Modifications to ECE/TRANS/WP.29/GRSP/2025/27* and ECE/TRANS/WP.29/GRSP/2025/44

The amendments apply to the 10, 11 and 12 series of amendments. It is therefore a proposal for supplement 1 to the 10 series of amendments, supplement 2 to the 11 series of amendments and supplement 1 to the 12 series of amendments to UN Regulation No. 17 (Strength of seats, their anchorages and head restraints).

Annex 4, figure 4-1, amend to read:

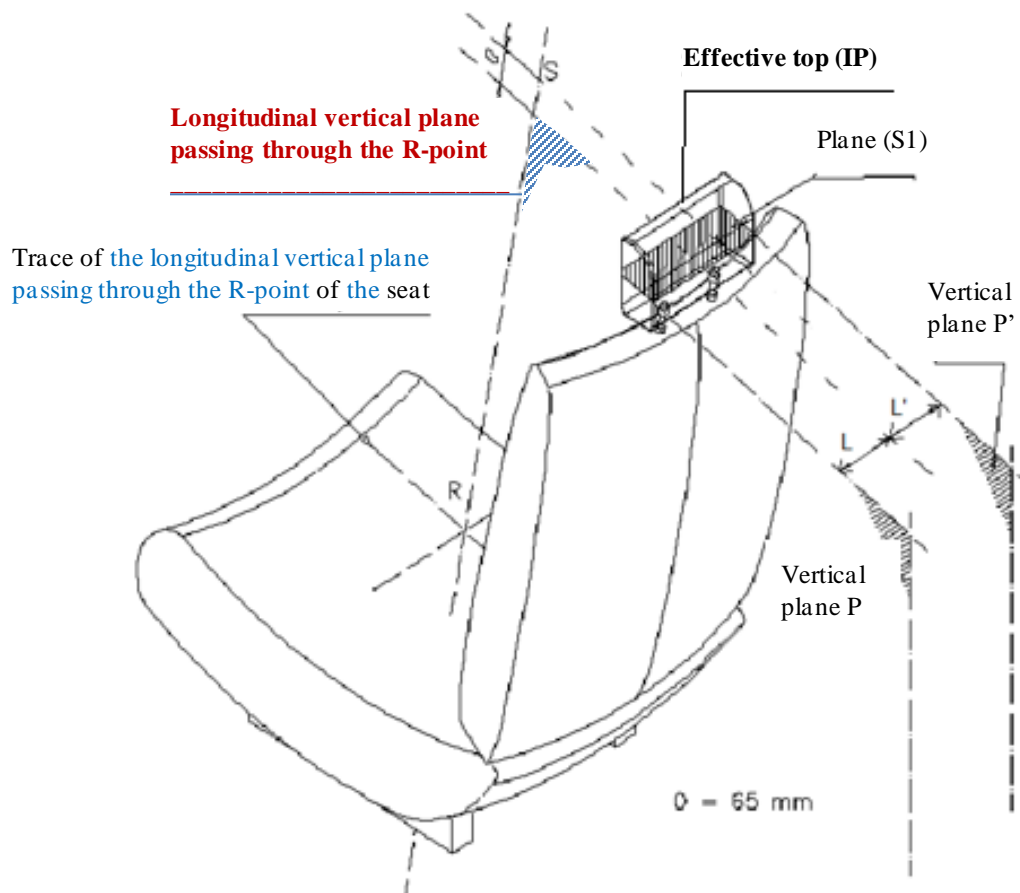
“2.4. Measure the distances L and L' in the plane S1 between the ~~vertical longitudinal planes *) passing through the torso line~~ **longitudinal vertical plane passing through the R-point** and the planes P and P'.”

7. In Annex 4 to this regulation, the Minimum Width Measurement Test Procedure is defined. Figure 4-1 was updated between the 09 and 10 series of amendments but some information is missing on the figure, including effective top. The figure was updated accordingly.
